WASHINGTON PUBLIC POWER SUPPLY SYSTEM

Subject: NUCLEAR PROJECT NO. 3  
RESOLUTION OF KEY LICENSING ISSUES  
FINAL SUBMITTAL OF SOIL STRUCTURE  
INTERACTION INFORMATION

WASHINGTON PUBLIC POWER SUPPLY SYSTEM  
WNP-3 SEISMIC DESIGN BASIS MODEL VALIDATION EFFORT  
AUGUST 1988

Figure 2f-7

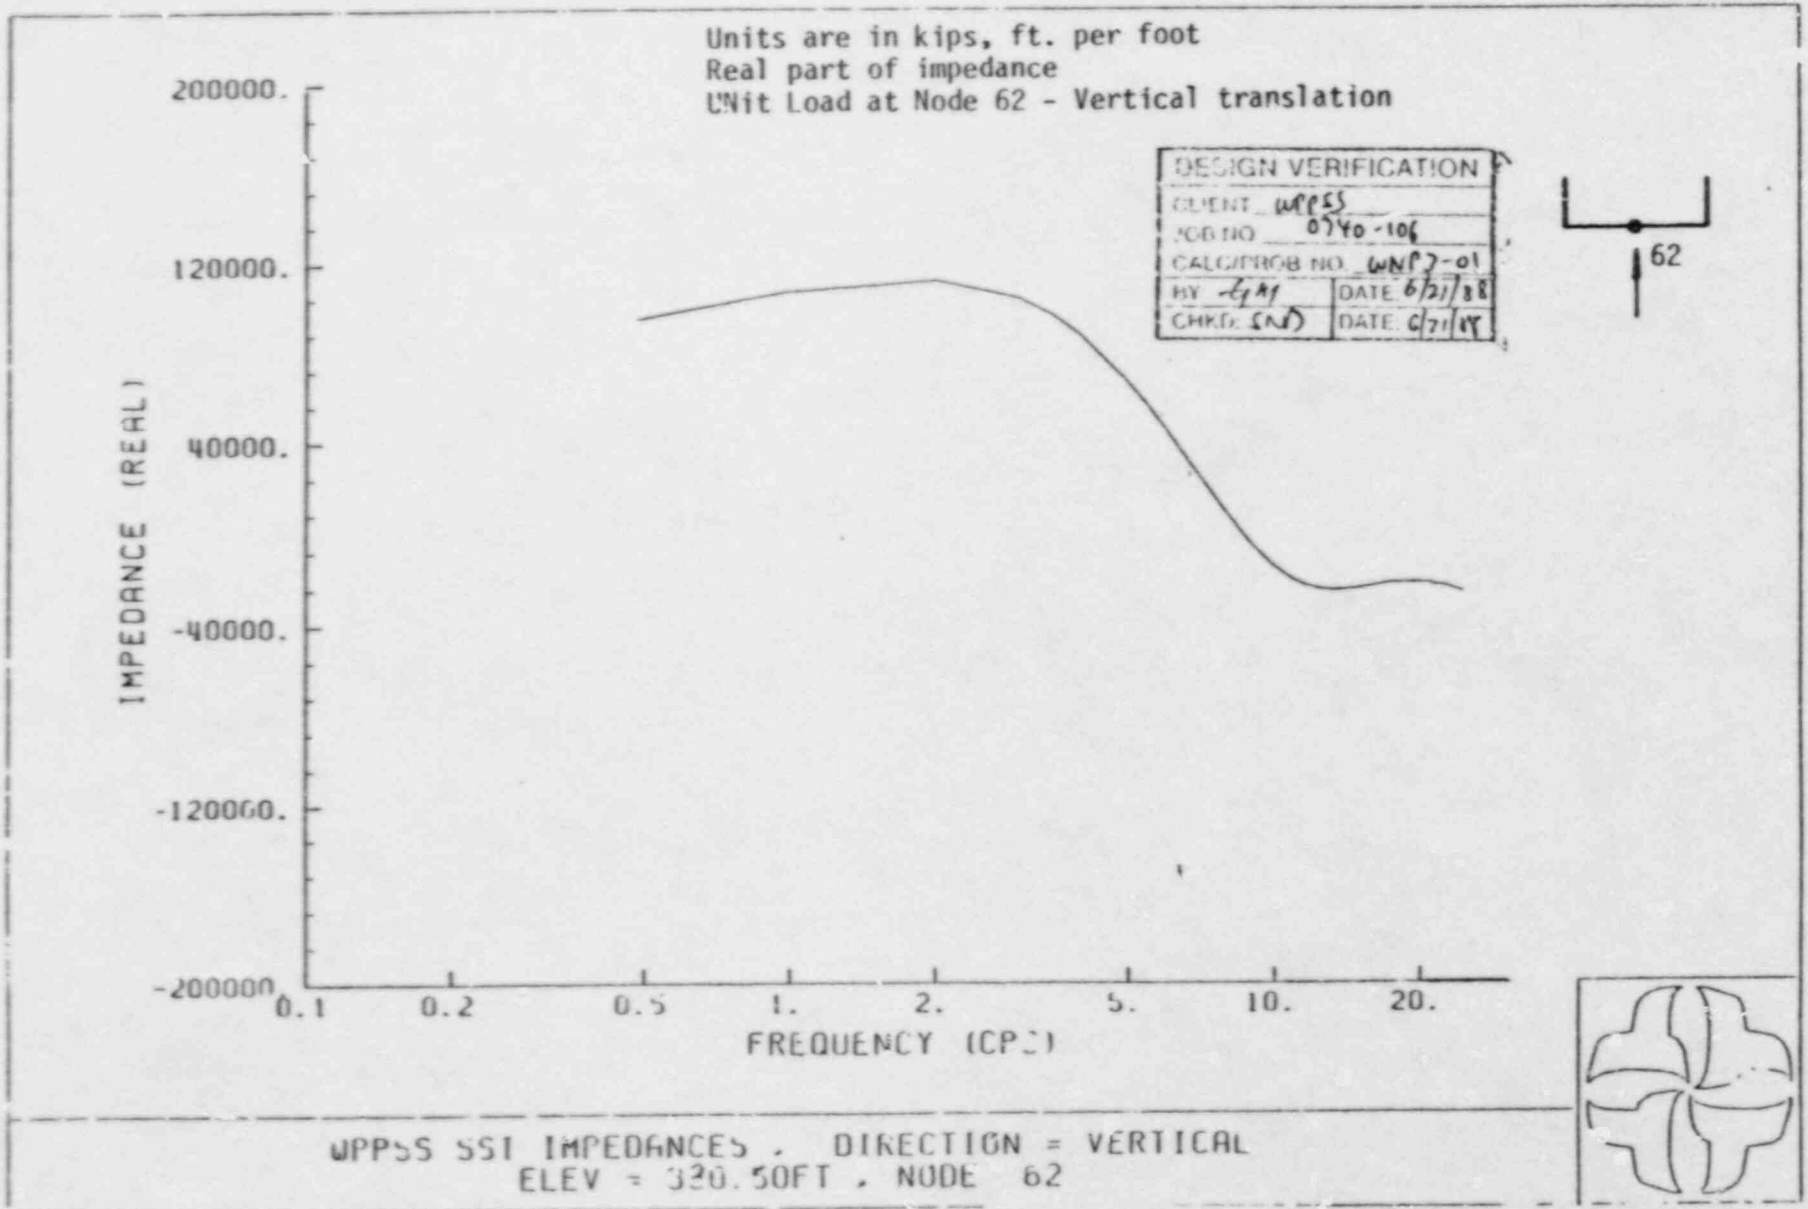
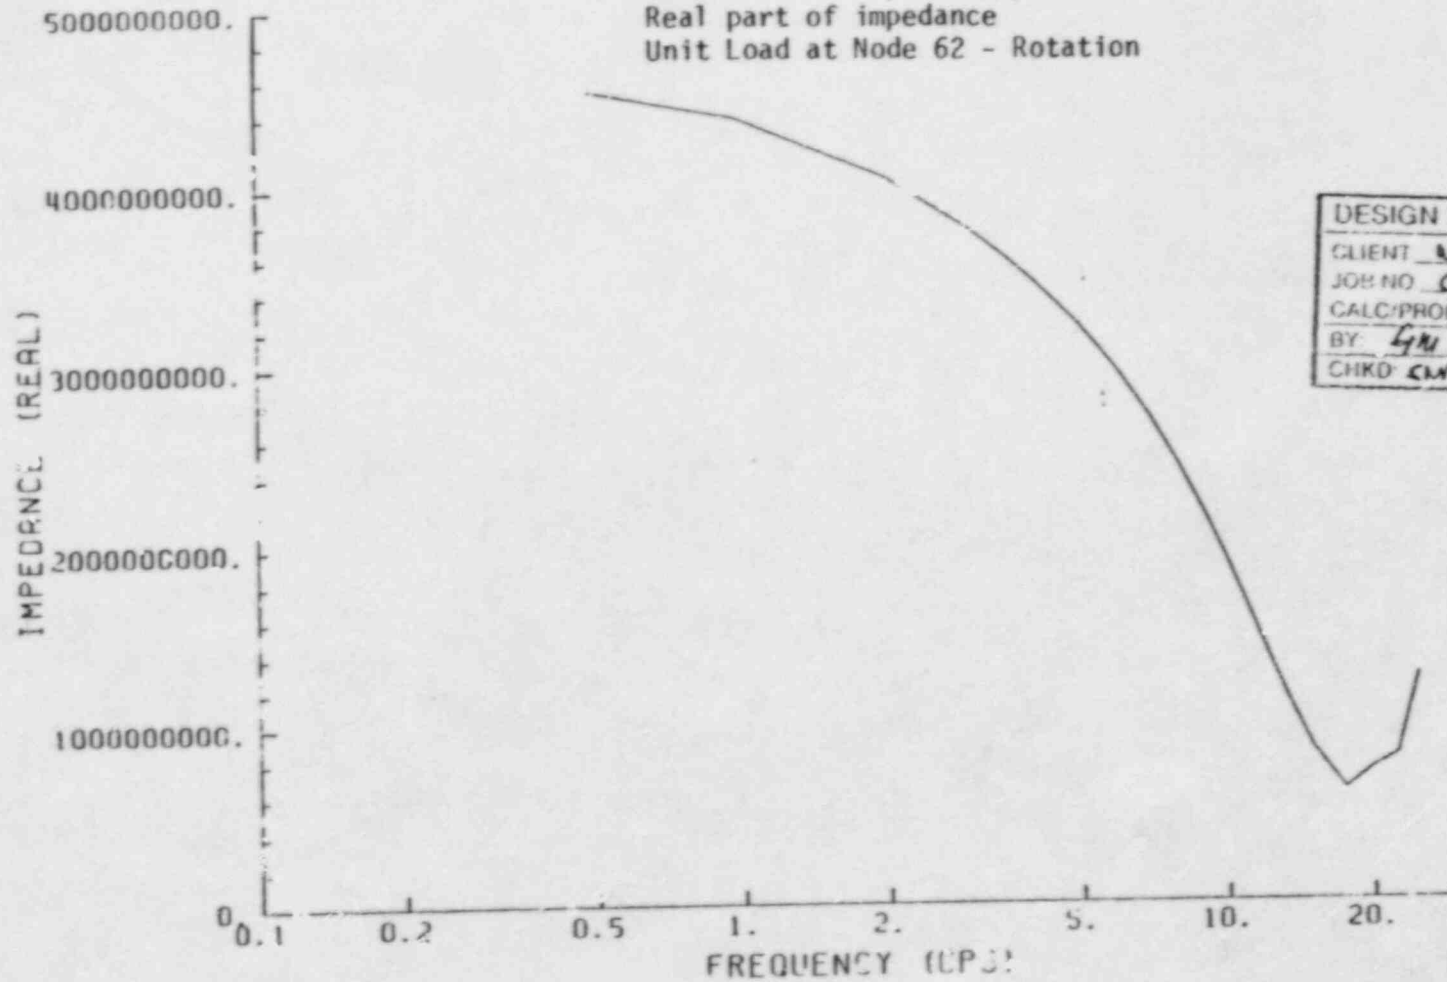
Review of the real part impedances for the vertical and rocking basemat cases (Figures 2f-6 and 2f-7) show a strong dependence with frequency. Taken as an isolated result it would appear from the results of Figures 2f-6 and 2f-7 that utilization of static foundation impedances are not appropriate for the

vertical and rocking modes. However, if the model responses (Item 3a) are examined between the frequency domain solution (SASSI) and the static half space solution, then it can be inferred that the use of static vertical and rocking foundation impedances provides satisfactory results since the character of the responses are similar.

The apparent lack of model sensitivity to the frequency variation in vertical and rocking foundation impedances is judged to result from two primary analysis factors. First, in the SASSI solution the complex frequency dependent stiffness matrix, included in the equation of motion for the complete solution, is of the form:

Figure 3a-2

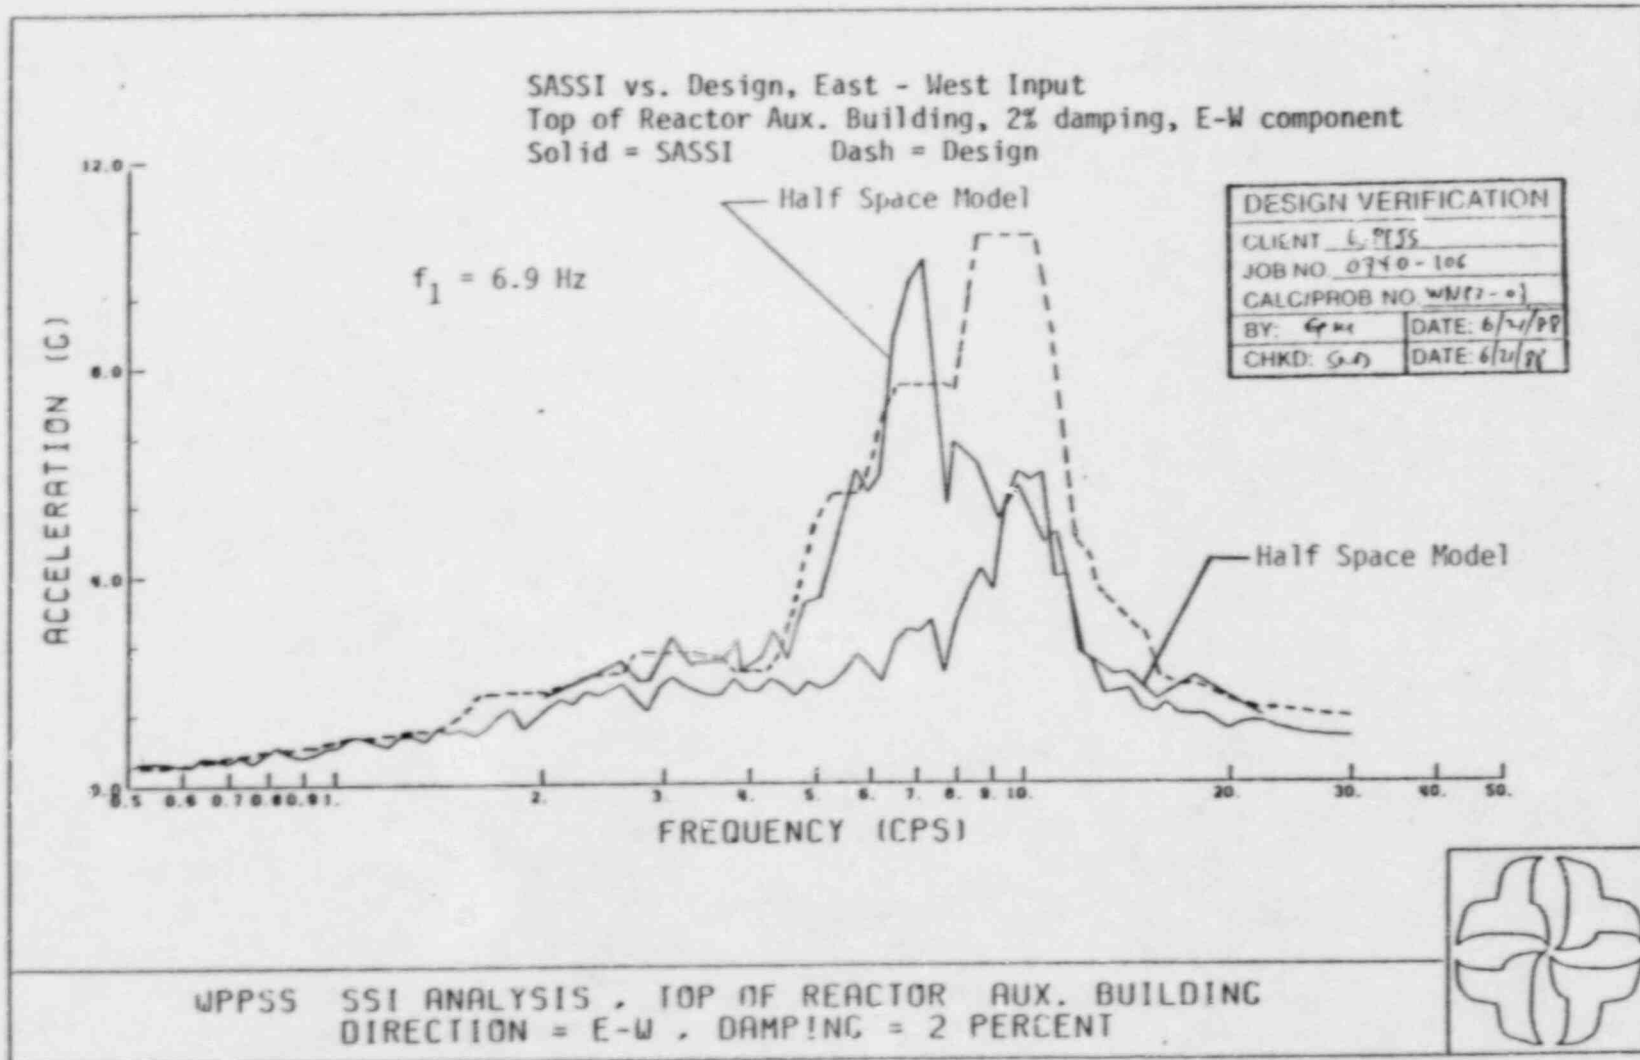
Figure 3a-2 shows that the peak of the half space response for the RAB is near the fundamental response of this structure (6.9 Hz). Whereas both the SASSI and design basis models shift the spectral response of this foundation-interfaced structure up to near 10 Hz. A stiffening affect with the surrounding foundation media is judged to cause this shift. The discrete soil support interfaces (i.e., lumped foundation springs) applied in the half space model would in effect yield less constraint on the RAB than the continuous finite element boundaries applied in the SASSI and design basis model techniques. In any case, the SASSI results at 6.9 Hz are (by a factor of three) far below either the design basis or half space results (see Figure 3a-2).

Figure 3a-8

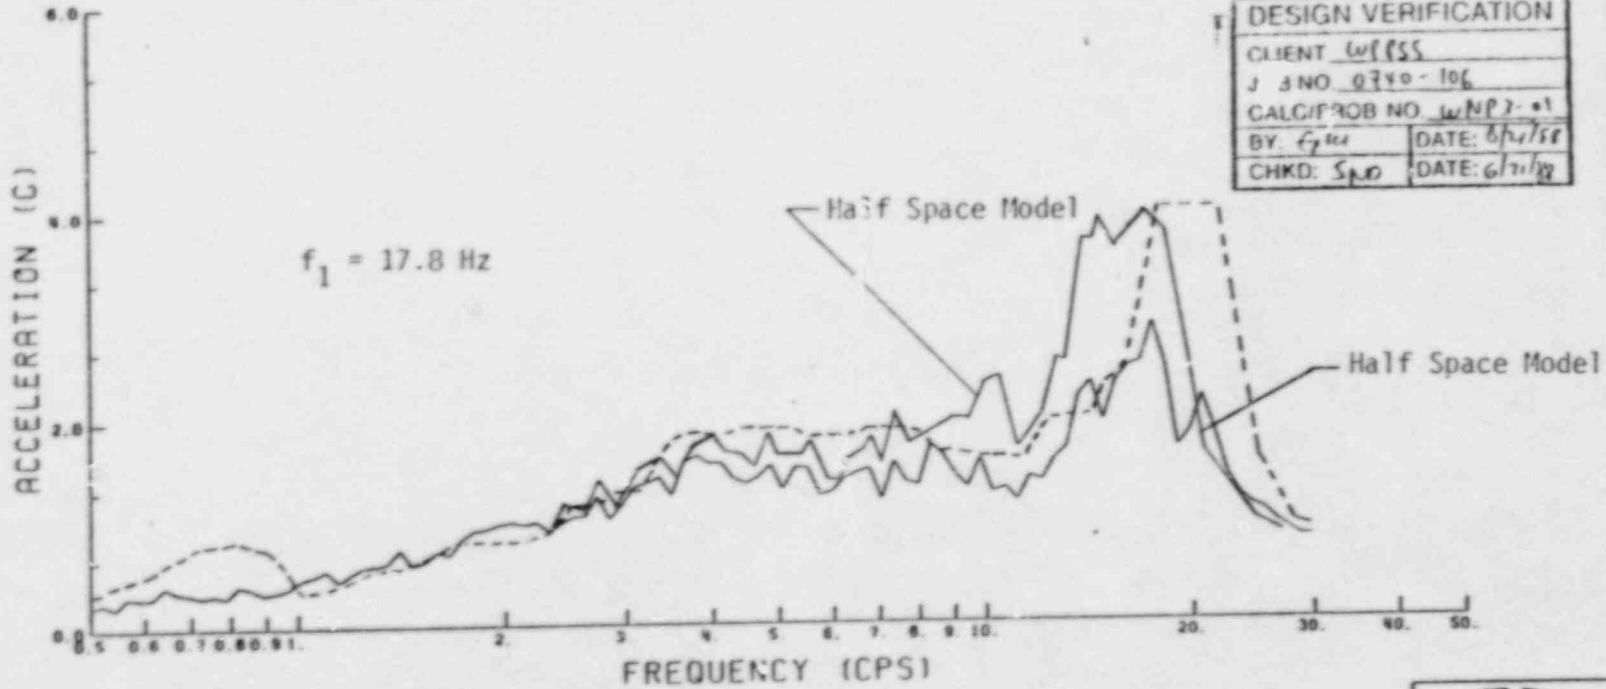
Examination of Figure 3a-8 shows a small exceedance of the design basis spectra at approximately 13 to 15 Hz, but the associated containment fundamental vertical frequency, although close, is higher (17.8 Hz). Thus, direct building frequency matching at the exceedance does not result, however, containment mounted subsystems active in this frequency regime could experience an approximate 10 percent vertical component seismic load increase. But again, it is noted that the exceedance is small, and further, that the relative acceleration magnitude compared to the horizontal response is small. Furthermore, WNP-3's total seismic loads are derived as the SRSS combination of the two horizontal and the vertical direction as required by Regulatory Guide 1.92. Thus, a minor exceedance of the vertical component is greatly suppressed by the combination of the larger horizontal responses. Of course, other design conservatisms in terms of design allowables, damping, as well as the basic conservatism of assuming concurrent maximum responses for all three directions of seismic motion (as cited by Newmark, R.G. 1.92), all compound to form a very large margin of safety.

Other exceedances (outside of the building frequencies of interest) do occur with the half space model. Specifically, Figures 3a-8 and 3a-9 show frequency shifts and magnitude increases which are significant. These exceedance are mitigated largely in that they are relatively low magnitude vertical responses (i.e., SRSS combination effects), and secondly, subsystem evaluations (June 1984 submittal) show substantial design margins of safety.

Figure (AF-1)-1

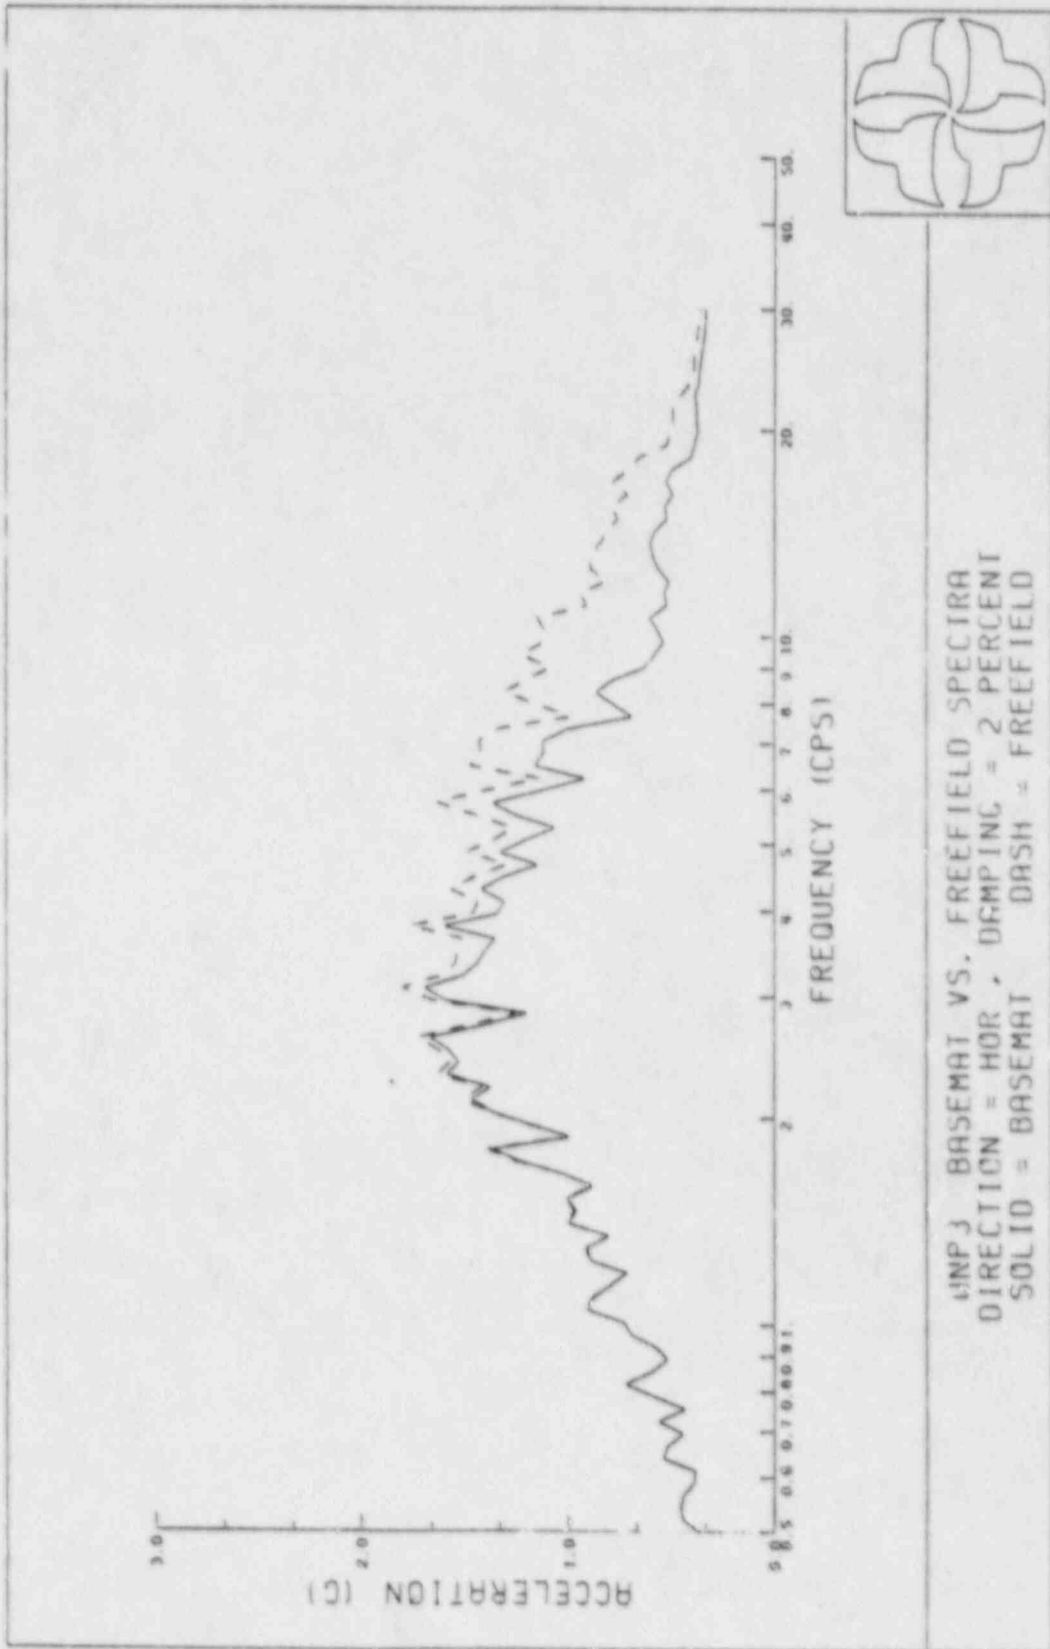
Figures (AF-1)-1 and (AF-1)-2 show a comparison of the SASSI spectral results obtained at the basemat foundation elevation with the free-field or control motion input to the SSI analysis. These figures depict the effects due to SSI. As expected, it is seen that some reduction does occur as compared with the free-field motion. Also as expected, the interaction effects are shown to be more significant in the range of the structural frequencies (e.g., approximately 3 to 20 Hz, depending on motion direction, with reductions as large as 45 percent). At very high frequencies, the free-field motion and the interaction motion are basically identical. This particular effect demonstrates the conservatism of the SASSI calculations. In addition, the SASSI methodology has been shown to conservatively predict reductions of motion over the embedment depth as compared to actual recorded responses. This was demonstrated, for example, by the Lotung experiment where SASSI predicted reductions of a lesser magnitude than those actually recorded.

In conclusion, the Supply System finds that deconvolution in a rock media is substantiated by theory and published seismic data for comparable rock sites. Thus, the Supply System recommends that the NRC's concern as identified in AF-1 be closed.
